BOOHER 2ND ADDITION TO SEDGWICK COUNTY, KANSAS

RE: S/D 99-13 -- One-Step Final Plat of BOOHER 2ND ADDITION

RE: S/D 99-13 -- One-Step Final Plat of BOOHER 2ND ADDITION

CASE NUMBER: S/D 99-13 - BOOHER 2ND ADDITION

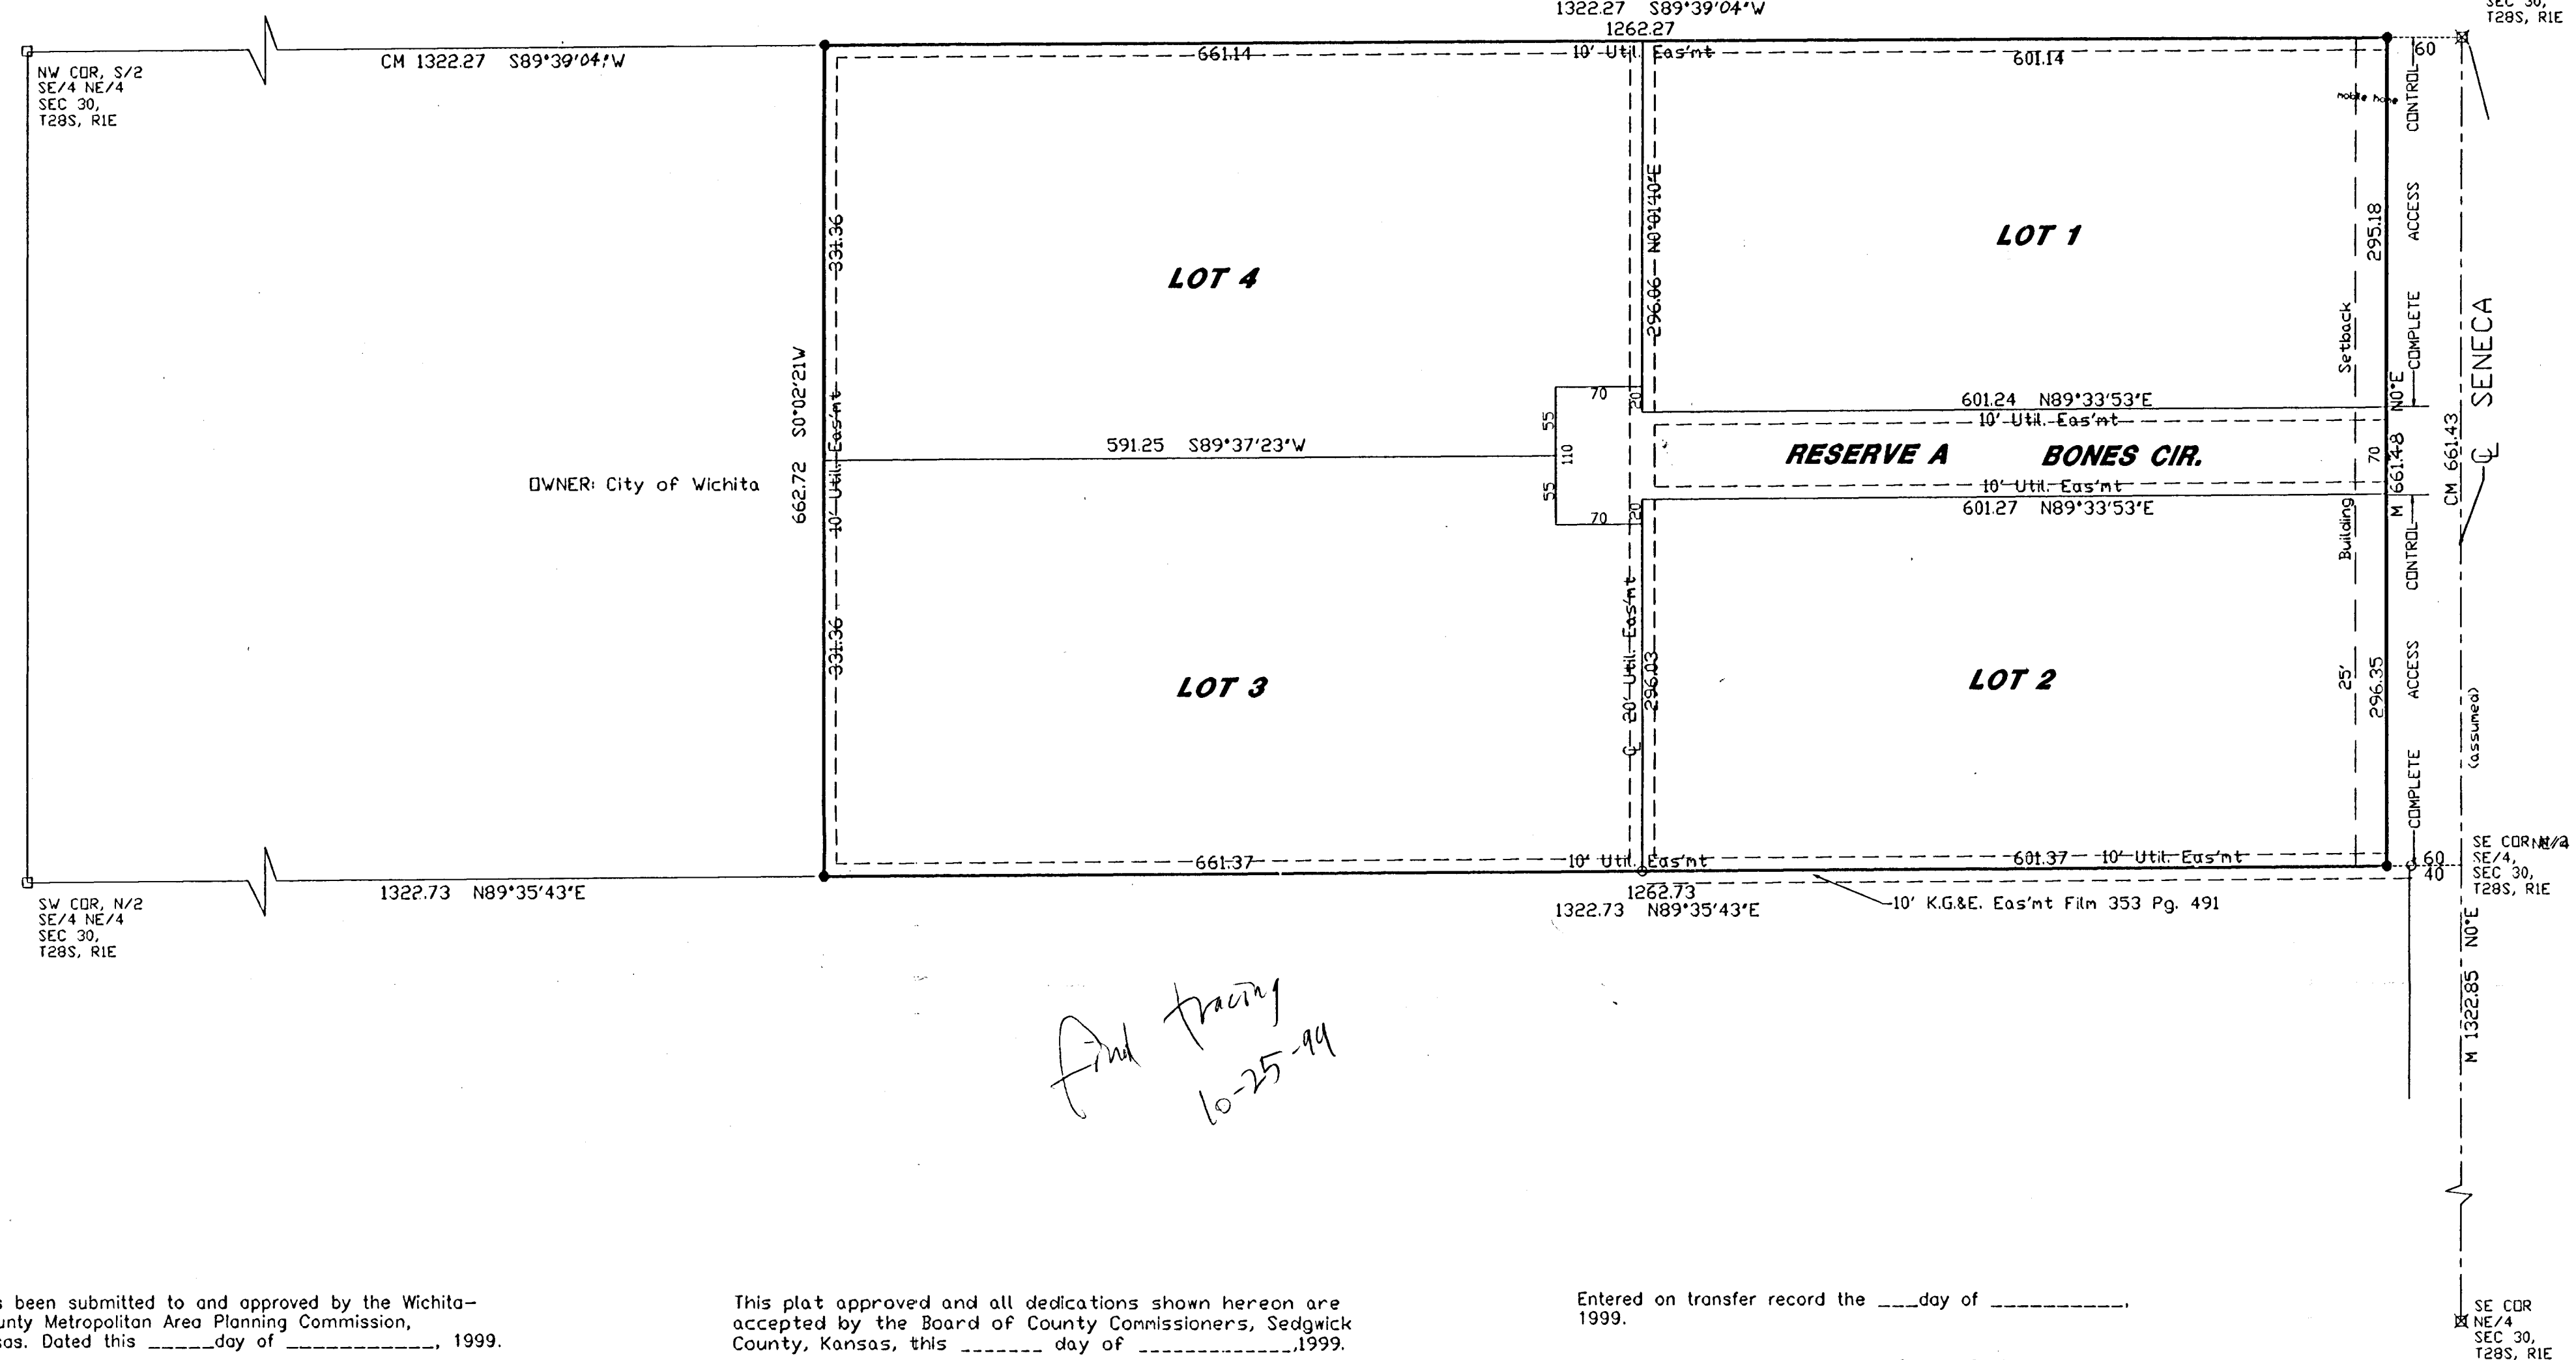
✓ A revised lot layout is needed indicating at least 4.5 acres per lot unless the site is approved for septic systems.

E. The applicant proposes a private street to access the four lots. Subdivision regulations require private streets to be platted as reserves. These reserves need to be platted as distinct entities and not denoted as part of any adjoining lot.

→ F. A covenant shall be submitted regarding the reserve platted for private drive purposes, which sets forth ownership and maintenance of the private drive, and future reversionary rights of

- G. The final plat tracing shall denote complete access control along Seneca to the north and south of the private street. Access controls shall be referenced in the platlor's text.

- H. The private street shall be designated a name and approved by the County Fire Department. *Bones Circle is recommended*
- I. The County Commissioners signature block needs to be revised to reference "Thomas G. Winters" and "Bill Hancock".

- J. The MAPC signature block needs to be revised to reference "William M. Johnson".
- K. According to the platting binder, a blanket pipeline easement appears to have been granted over the plat. The applicant shall either obtain a release of this easement or provide proof that the easement has been confined. If confined, any portion of the easement if on this plat shall be shown and the pipeline's name and recording information shown.

- M. County Fire needs to comment on the acceptability of the hammerhead turnaround.
- N. The applicant shall install or guarantee the installation of all utilities and facilities which are applicable and described in Article 8 of the MAPC Subdivision Regulations. (Water service and fire hydrants required by Article 8 for fire protection shall be as per the direction and approval of the Chief of the Fire Department.)

- T. Recording of the plat within thirty (30) days after approval by the City Council and/or County Commission.
- U. The representatives from the utility companies should be prepared to comment on the need for any additional utility easements to be platted on this property. Southwestern Bell and KGE have requested additional easements.
